**DOCUMENT 00 90 00
ADDENDUM**

ADDENDUM NO. [2] Date: October 11, 2022

**RE: New Richmond Kitchen & Canine Rm Renovation
 Northwood Technical College
 HSR Project 21066-1**

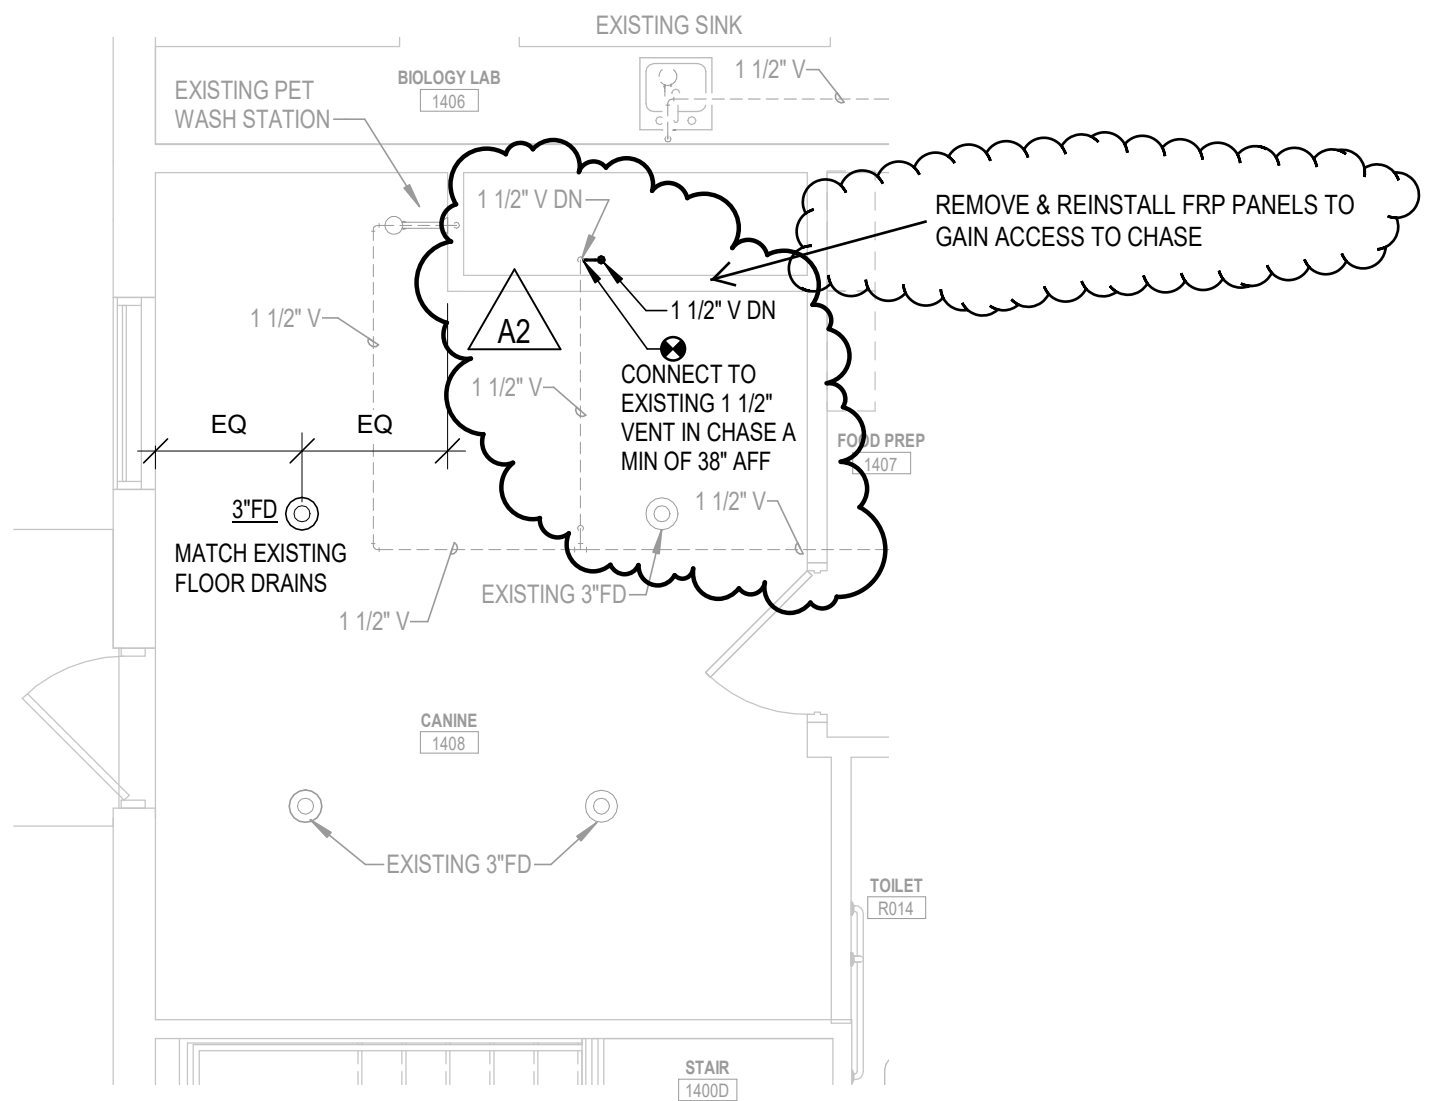
1. Sheet P003:
 - a. Revise existing conditions per site verification at walk-through.
 - b. Revise new 3" floor drain pipe routing and connection location to existing 3" sanitary main.
 - c. Add 1 ½" relief vent for floor drain circuit venting for canine room.

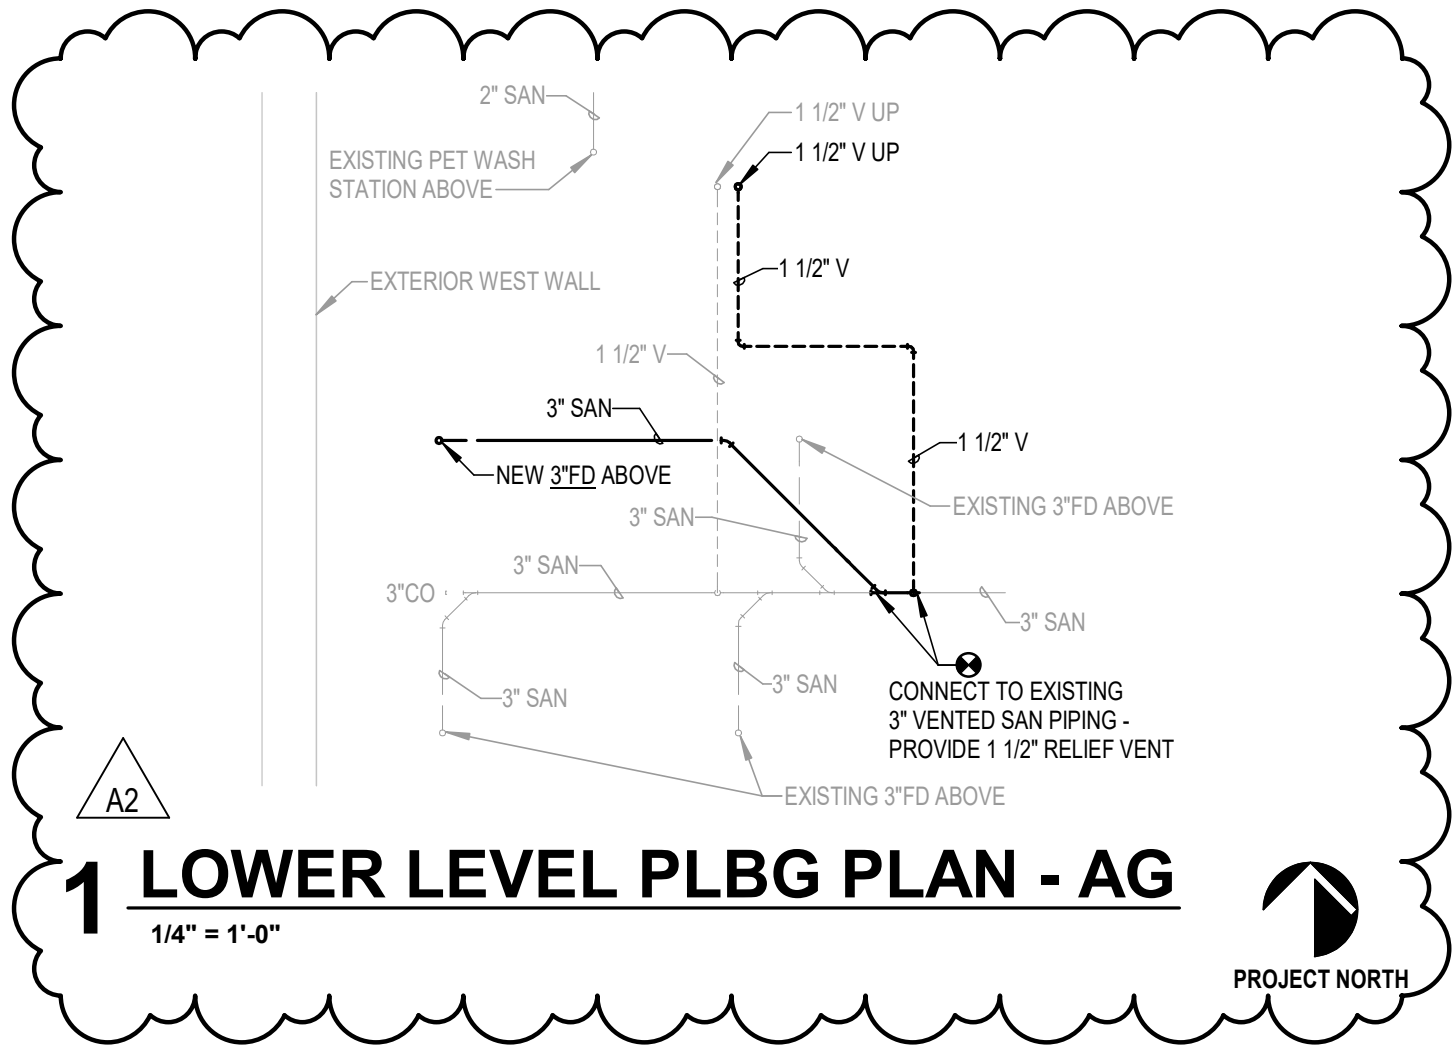
2. Sheet P004:
 - a. Revise Sanitary Plumbing Isometric per changes to plans in this Addendum.
